Re: 8224 Reservoir Rd
Fulton, MD 20759
Percolation Certificate Plan Waiver

Percolation Test Report; 8224 Reservoir Road, Fulton, MD 20759

Good morning. The perc cert plan for 8224 Reservoir Road has been reviewed with the following comments:

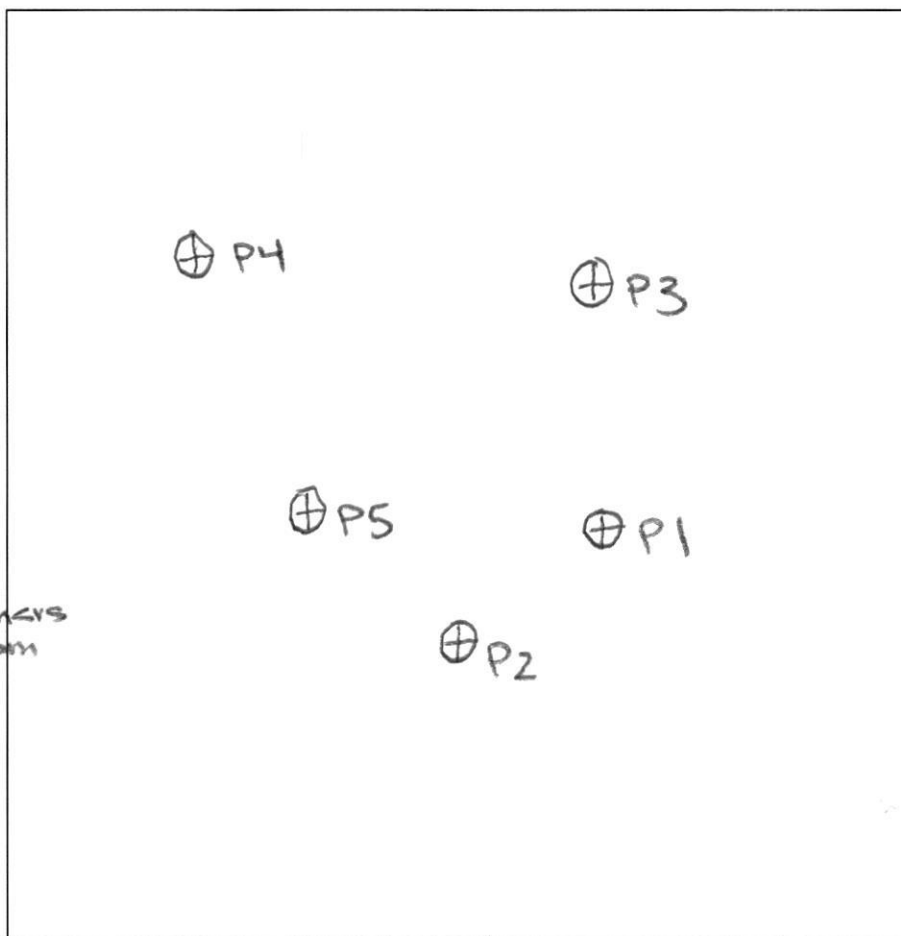
0.5' - brl
yellowish
br scl
4' - sbk
yellowish
red sl
yellowish
br sl
w/ mica
11' - 5% schists
channers
11.5' - hard bottom

0.5' - brl
yel br
scl
4' - yellowish
red
scl
yellowish
br/tan
sl weak
pl
micaceous
12' -

0.4' - brl
pale red
scl
4' - yel tan
sl
dense pl
micaceous
5% schists
channers
12' -

DATE	TEST #	DEPTH	START	BREAK 1" DROP	STOP 2" DROP	TIME OF 2ND INCH	P/F/H
3/10/22	5	5'/11.5	8:21	8:34	8:48	14	P
3/10/22	4	5'/12'	8:27	8:29	8:34	5	P
3/10/22	3	5'/12	8:51	8:56	9:09	13	P
3/10/22	2	5'/12'	9:33	9:36	9:48	12	P
3/10/22	1	5'/12	10:21	10:43	11:27	44	F
3/10/22	L	6'/12	11:37	11:44	11:59	15	P

0.5' - brl
yellowish
br scl
w/ mica
4' - yellowish
red sl
shaly
2.5'
12' -

brl
yel br
scl
4' - tan
sl dense
schists pl
channers
12' -
